TO: Honorable Mayor and City Council Members
FROM: J.H.Kerr III, City Planner 
DATE: April 16, 2008
SUBJECT: Sparkman Ridge Subdivision – Site Plan

RESOLUTION NO. 470-08

Sparkman Ridge Site Plan

SUBJECT: CONSIDERATION OF SPARKMAN RIDGE SITE PLAN
PARCEL NO. 8010-00-00-0020 - SITE PLAN DATED: January 22, 2008

Exhibit B
Resolution 470-08
Sparkman Ridge Subdivision

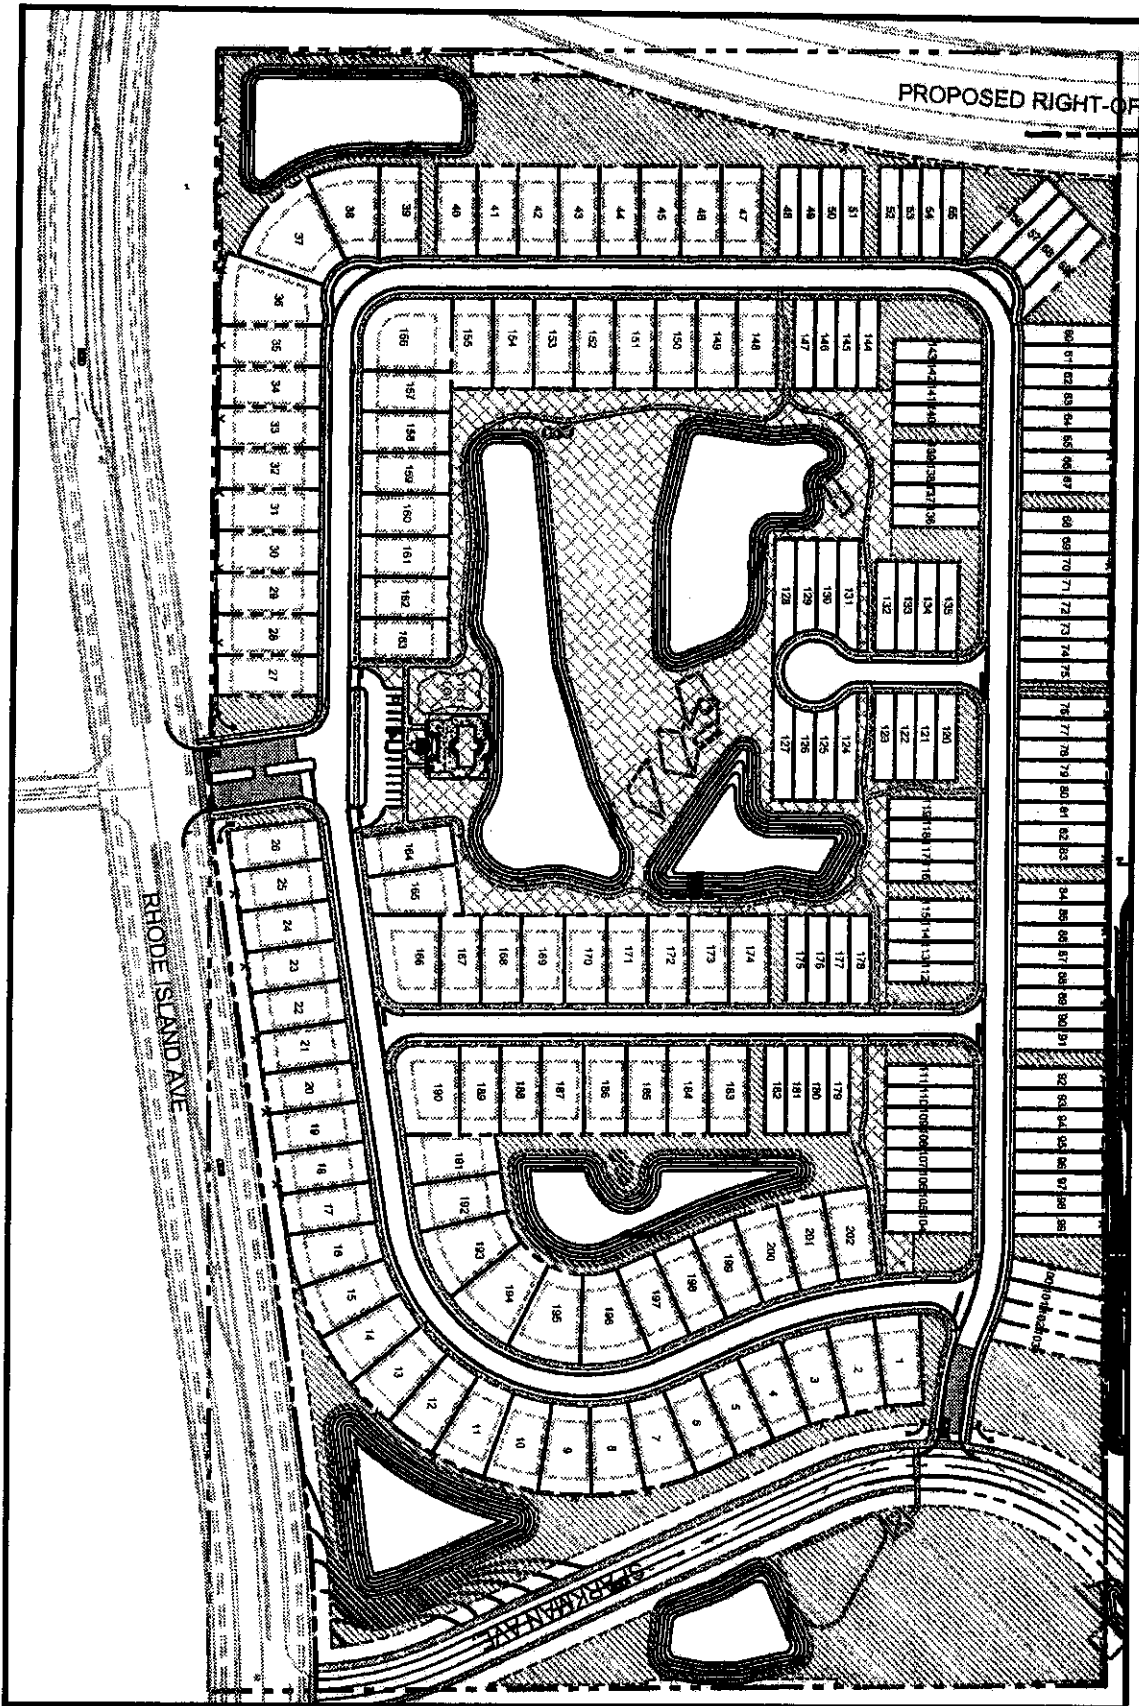
The City's land development code requires that townhouse building elevations must reflect a design consistent with the other proposed buildings. Building elevations were not submitted as required by Section 10 because the applicant is uncertain as to the ultimate townhouse design at this time. As a result, staff was not able to determine compliance with the appearance standards. Staff recommends that at such time as the applicant is ready to develop the townhouse portion, the developer (or the townhouse portion) shall submit the townhouse building elevations required in Section 10 of the land development code, which will be reviewed and considered for approval by city staff prior to construction of the townhouses. The applicant has agreed to this condition, which is noted on sheet 3 (note 27) of the site plan.

Building elevations for the mail kiosk, clubhouse, and cabana were not submitted as required by Section 10. The building elevations must reflect a design consistent with the other proposed buildings. As a result, staff was not able to determine compliance with the appearance standards. Staff recommends that at such time as the applicant is ready to develop the mail kiosk, clubhouse, and cabana, the developer shall submit the mail kiosk, clubhouse, and cabana building elevations required in Section 10 of the land development code, which will be reviewed and considered for approval by city staff prior to the issuance of a certificate of occupancy on the first dwelling unit. The applicant has agreed to this condition, which is noted on sheet 3 (note 28) of the site plan.

A sidewalk has been depicted between Lots 47 and 48, which will run in a westerly direction and connect to a future sidewalk within the proposed Western Parkway right-of-way. A note has been added at staff's request, regarding the sidewalk being installed by the homeowners association at such time as the Western Parkway is constructed. However, staff is concerned about the children attending the middle school, and the need for direct access to the middle school from this subdivision. Staff believes this sidewalk should be extended in a northerly direction to the entrance to the basketball courts at the middle school to be constructed at the same time as the other sidewalks in the subdivision.

Staff is concerned about the proximity of the sinkhole to Sparkman Avenue, of which a cross section of the proposed Sparkman Avenue and the existing sinkhole is depicted on Sheet 8 of the site plan. It appears that the sinkhole slope may be too close to the edge of the road, and fencing may be required. The need for a fence and/or other safety precautions will be determined by the City Engineer at time of street construction. Staff recommends approval of the site plan subject to the developer providing an architectural fence to be installed at the sinkhole location, if, following construction of Sparkman Avenue, it is determined by the City Engineer that a fence, or other suitable safety precaution, is required because of the sinkhole slope or proximity.

Staff is concerned about certain issues that had arisen in another subdivision, which were caused by 50-foot wide lots (and the 5-foot setbacks) similar to those within the approved Sparkman Ridge R-PUD. These issues consist of the side setback, building separation, side yard slopes, retaining walls, and mechanical equipment locations etc. In one case, some contractors located the air conditioners side-by-side between two houses, therein making it impossible to operate a lawn mower between houses, or to gain emergency access. In some cases, grade differences required retaining walls.

The applicant was made aware of the above, and as a result, has added three notes (21, 22, and 25) to Sheet 3 of the site plan in an attempt to address the issues. However, these notes do not adequately address all the issues listed above.

The four freestanding signs are proposed to be externally lit but the sign code requires that all freestanding signs be internally lit. The applicant has requested a waiver from this requirement because an internally lit sign does not fit into a residential community, and an externally lit sign is more aesthetically appealing in a residential community. Staff agrees with the applicant.

The majority of the property is proposed to be cleared of trees, except for the tracts. The trees on these tracts are proposed to be preserved, but the tracts will be cleared of all underbrush (bush-hogged), including the removal of any dead trees. Once these tracts have been cleared of underbrush, an inventory of the preserved trees will be conducted to insure the development meets the City's minimum tree requirement. The inventory must result in a minimum of 2,651 diameter inches of preserved trees. A total of 5,302 diameter inches must exist on site following development. Staff recommends approval of the site plan subject to staff conducting an inventory of preserved trees to verify compliance following the clearing of the property.

The site plan depicts a detail of the fence that will visually screen the rear yards of all lots facing the Western Parkway, Rhode Island, Sparkman Avenue, and the north property line. However, this fence detail on Sheet L1.2 depicts a 122-inch fence, whereas the maximum height is 6-feet within a residential development. Staff recommends approval of the site plan subject to the fence maintaining a maximum height of 6-feet.

The City's land development code (Section 4.5.5) requires a certain size park (3.03 acres) be provided by the developer and used for recreational (Section 7.4.C.8.d) purposes for the future residents of the subdivision. However, there are no specifications for recreational equipment. The applicant has provided the park land, and does indeed propose to provide the park equipment sufficient to meet the needs of the subdivision residents. Staff recommends the specifications for the recreational equipment be submitted for quality approval by staff prior to installation.

Staff recommends approval of the site plan subject to the developer providing a sidewalk between Lots 47 and 48, which will run in a westerly direction to the proposed

Staff recommends approval of the site plan subject to (1) a minimum 10-foot separation between roof eaves; (2) a minimum ground slope ratio of 6:1 within any single side yard; (3) any ground slope in side yards steeper than 6:1 must install a retaining wall; (4) any retaining wall must be engineered and constructed of concrete or landscape block and not wood; (5) maintain a minimum clearance of 4-feet in any single side yard; and (6) locate all mechanical equipment in the rear yard.

Staff recommends approval of the site plan subject to the four freestanding signs being externally lit provided the lighting fixture is part of the sign structure, and not as an external lighting fixture or external source. In other words, a low wall must be designed as part of the sign structure base that will visually screen the light fixture illuminating the sign. Staff will review the sign lighting design for approval when the sign application is submitted.
